Subject: Bangor Savings Bank

Windham Branch/Office Parking Expansion Response to Staff Review Comments

WINDHAM, MAINE

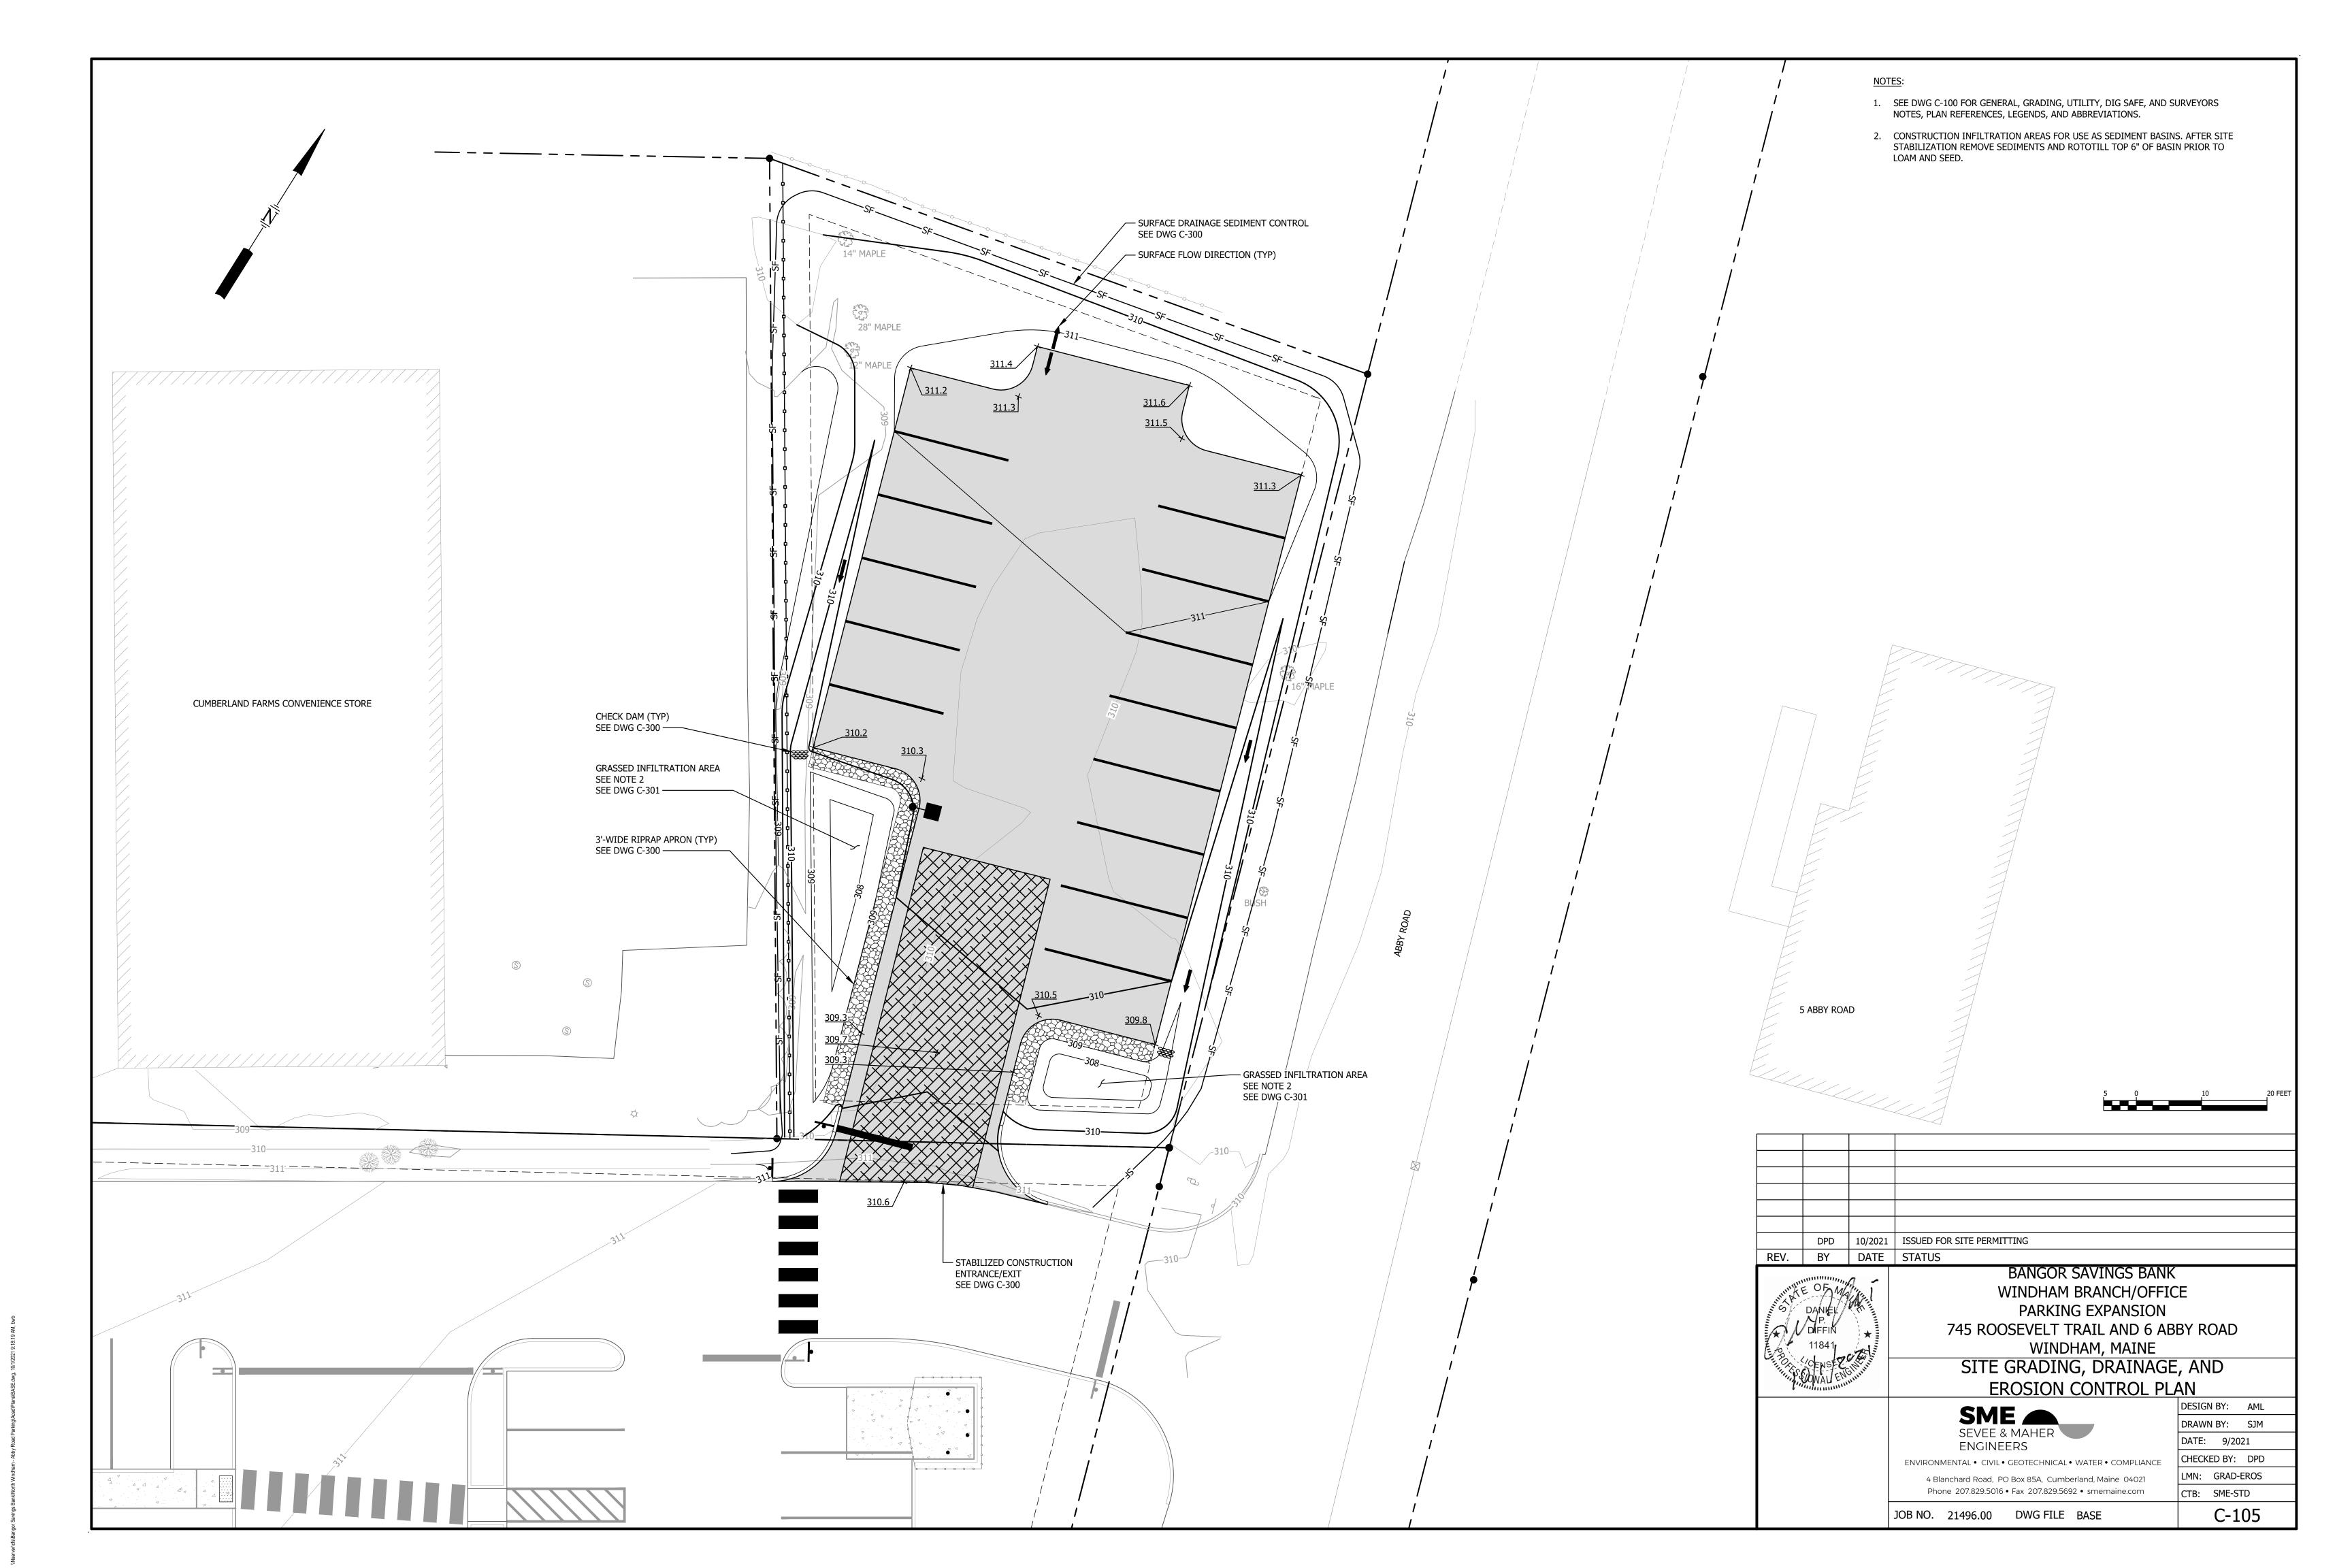
4. Please add "Amended" in the title block of Sheet C-102.

9. Please add the following

<u>SME Response</u>: Project plans have been updated to include "Amended" on Sheet C-102. A copy of the updated plan set is attached for reference.

<u>SME Response</u>: The Conditions of Approval were added to Sheet C-102. A copy of the updated plan set is attached for reference.

EROSION CONTROL NOTES AND DETAILS

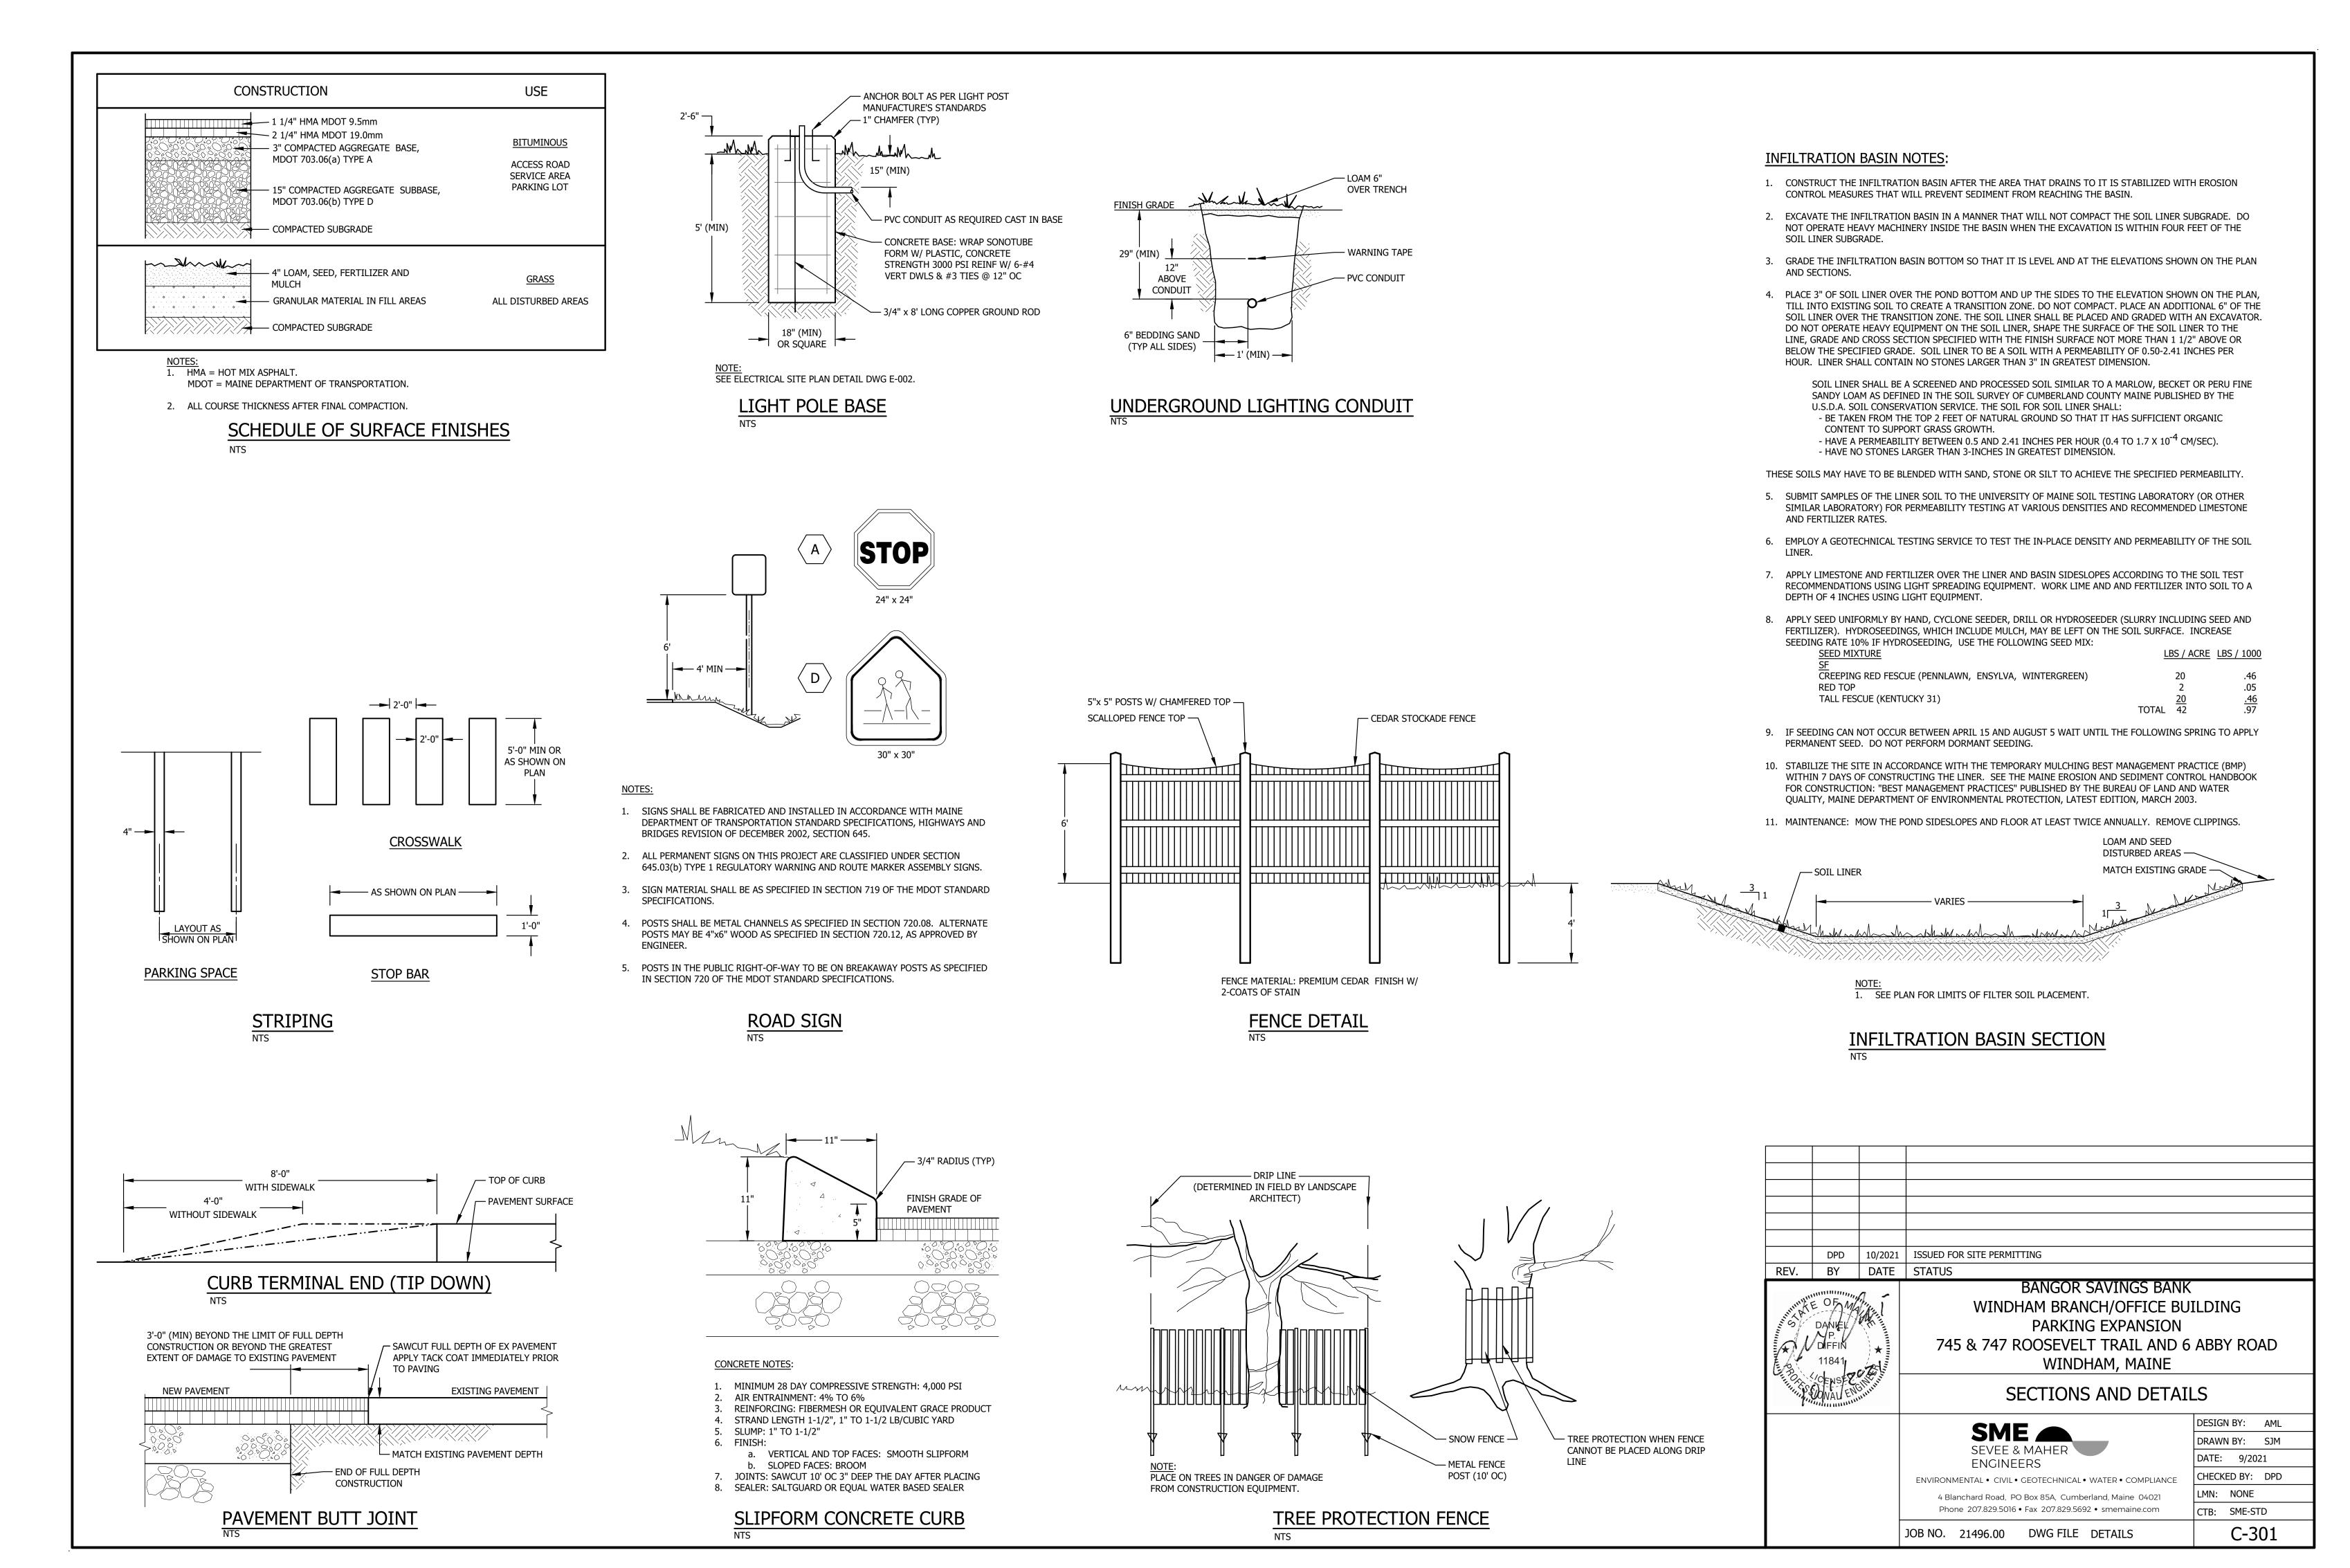
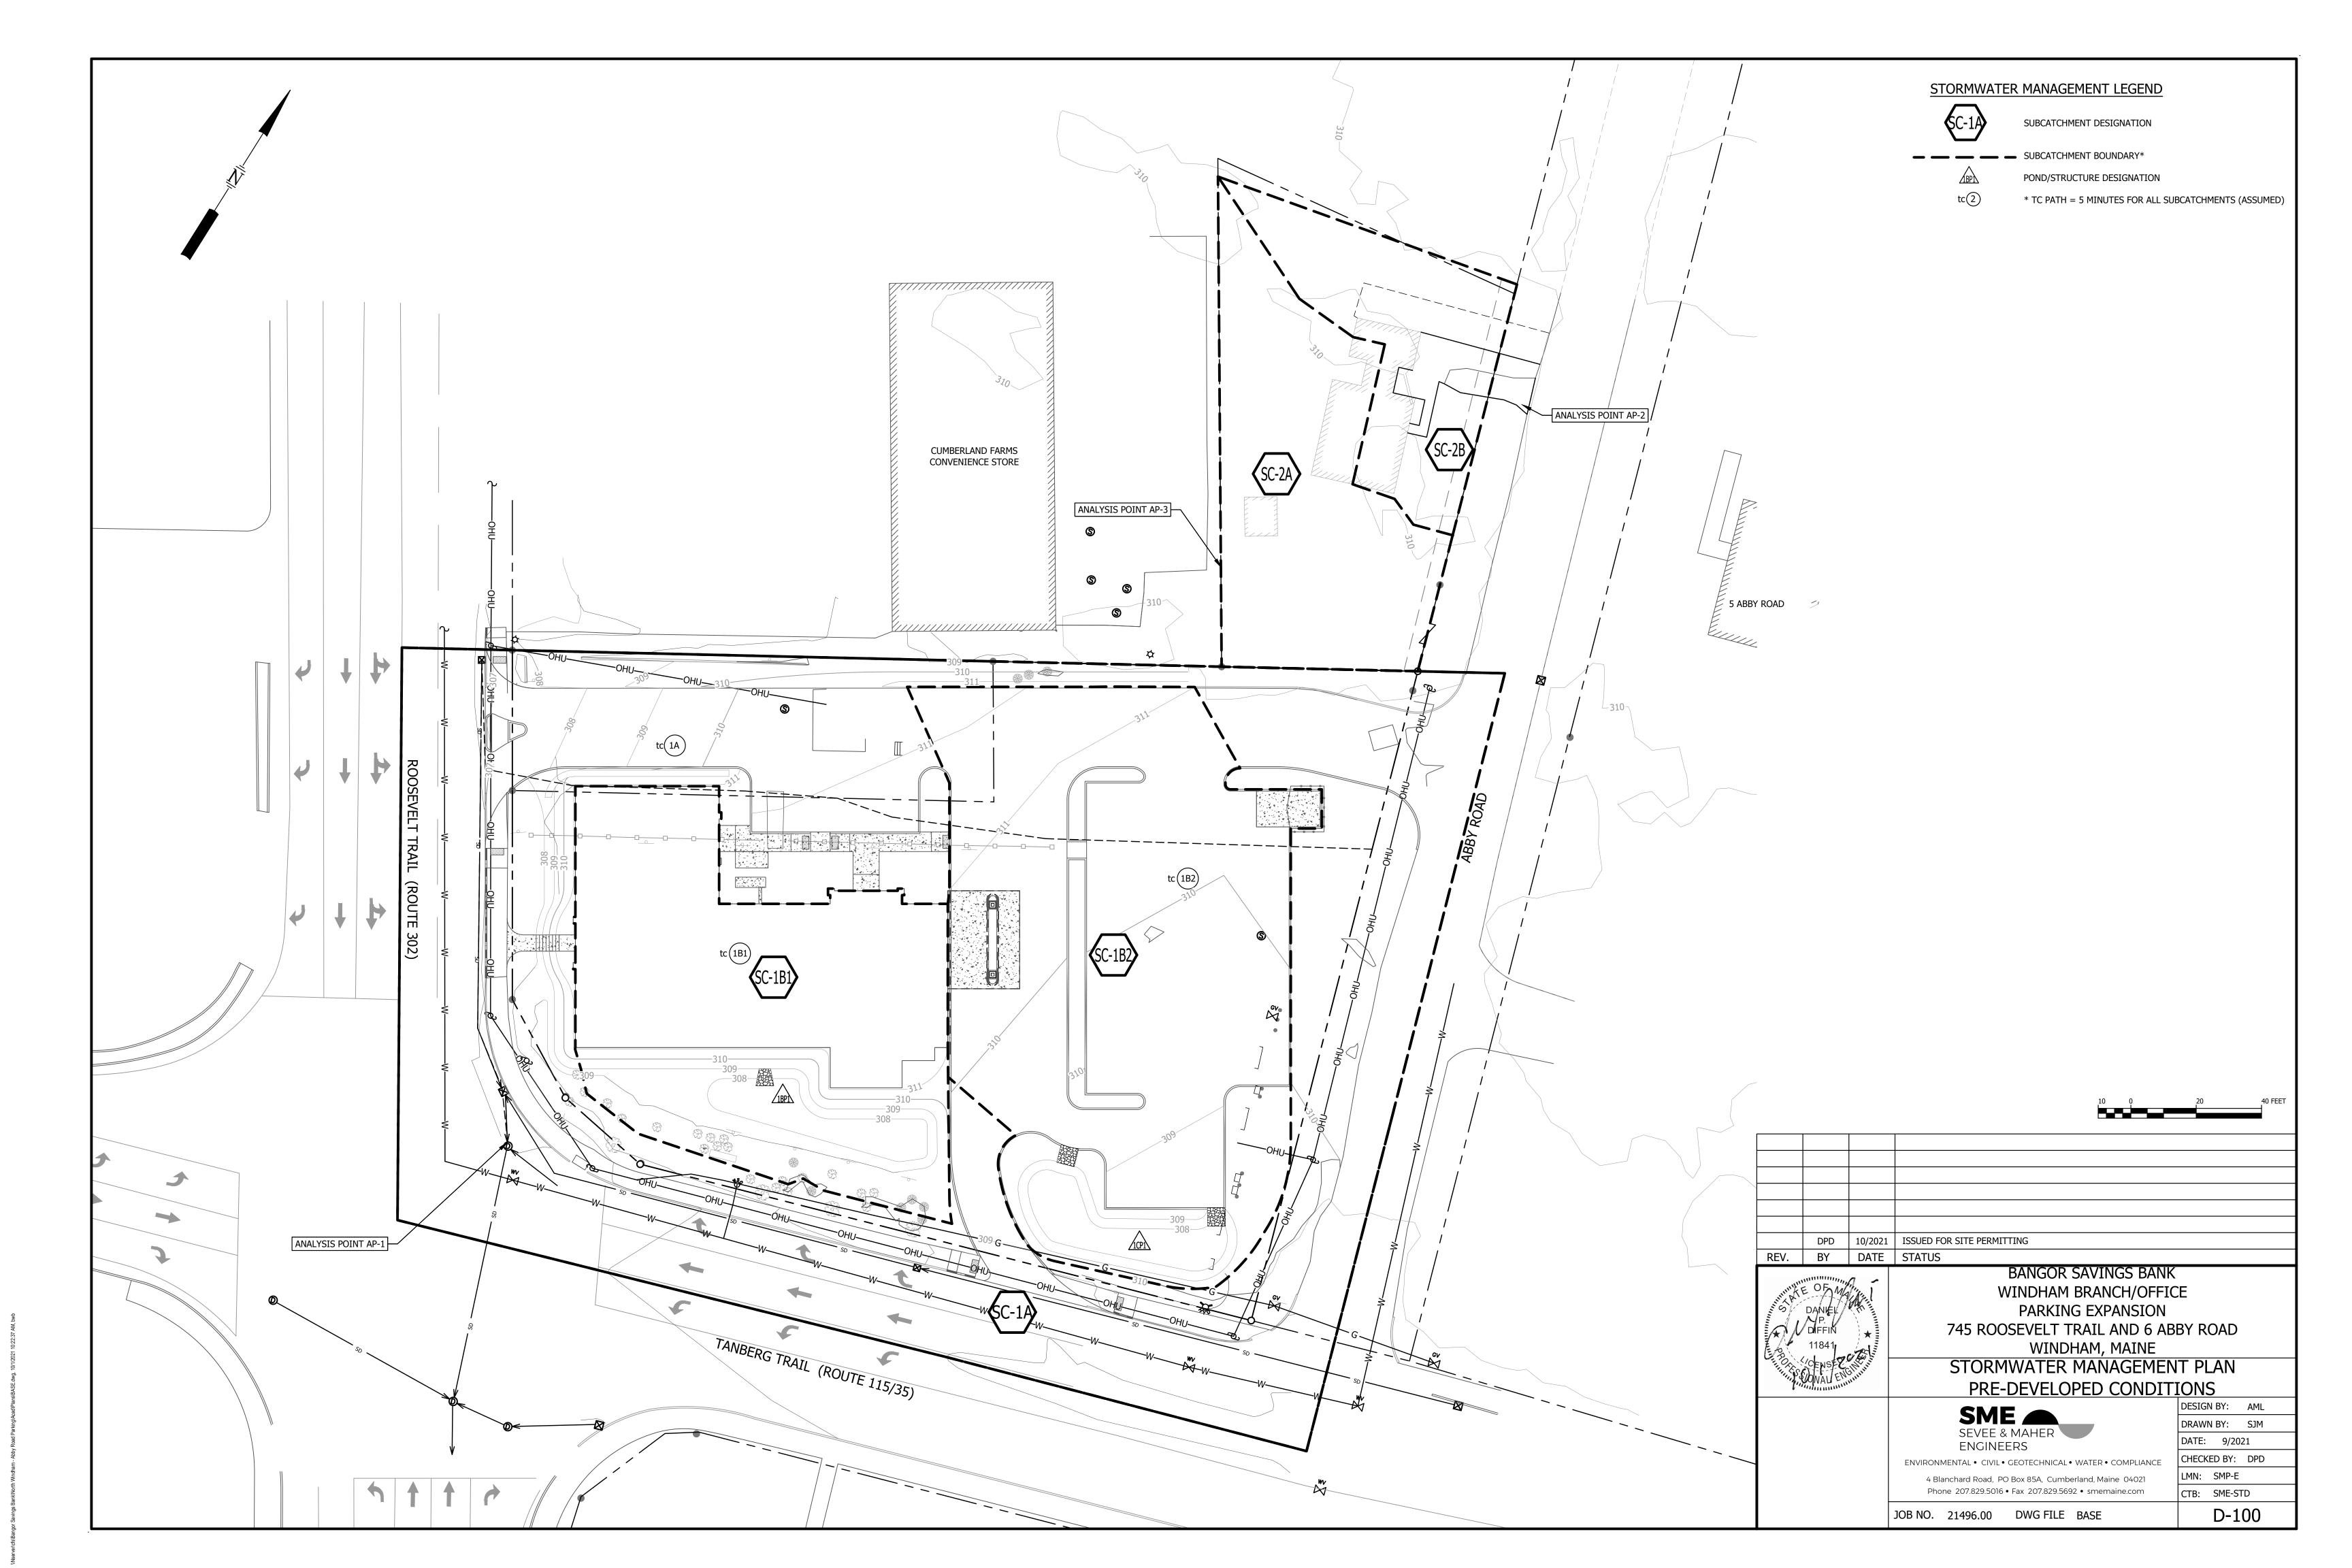
12. The proposed grading is 1H:1V or steeper along the westerly property line of the parking lot parcel. How will this be permanently stabilized?

<u>SME Response</u>: Steep slopes will be stabilized with riprap underlain by geotextile fabric. Locations of proposed riprap slope protection are identified on sheet C-105 and detailed on sheet C-300. The updated plans are attached to this letter.
